The Florida Fire Marshals and Inspectors Association, "Organization" (§633.026)

Informal Interpretation Request

National Fire Protection Association (NFPA) Document No. applied by the LFO: FFPC 18.2.3.2.2

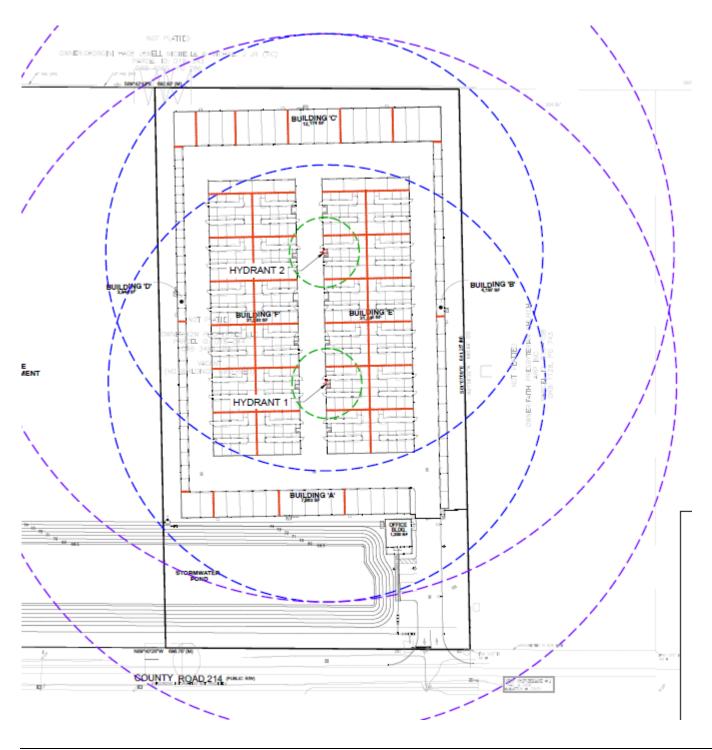
In this case, the exterior walls of the perimeter buildings (identified as Building A, B, C & D on the attached) are effectively 40' or less from the fire access road, so no change to our plan should be required. The exterior buildings in question are non-residential metal buildings with depths ranging from 10' to 40'. Each unit has a roll-up garage door and there are no interior hallways, so the exterior walls of the building are immediately accessible from the fire access road through the garage doors.

Since the perimeter building has the qualities described in Section II (non-residential, 40' or less in depth, no interior hallways, roll-up garage doors), is the exterior wall of the building considered 40' (or less) from the fire access road as currently designed?

Committees' majority answer: No

The exterior wall is not considered to be 40' or less from the access road. Measurements from the exterior wall to the fire department access road should not be made by going through the building
